TESLA	Tesla, Inc. Service Bulletin		Replace Both Side Repeater Cameras			
SB-22-17-004						
March 3, 2022						
Classification			Section/Group	Mobile Se	rvice	Configuration
Campaign Bulletin		17 - Electrical	Can Perforr permitted)	n (where	All	
Model Yea	ar Model		Country/Region	Build Loca	Build Location	
2020	Model S, M	lodel X,	All	Fremont	Fremont	
	Model 3					
	d model year(s) listed his bulletin for a particu		al approximation of the affected VIN li	st. Refer to the VIN/Bulletin Tra	acker or Custor	mer/Vehicle profile to determine

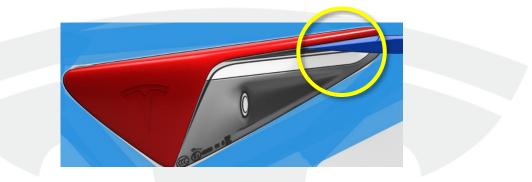
- a. Carefully insert a trim tool under the rear edge of the trim, and then separate it from the camera (Figure 1).
- b. Align the top of the new trim onto the camera, and then apply equal pressure to fully attach the trim onto the camera.

**NOTE - Model 3 Only:** The new side repeater camera aero rib trim comes in carbon black. If the vehicle currently has a chrome aero rib trim, replace the cabon black trim on the new camera with chrome:
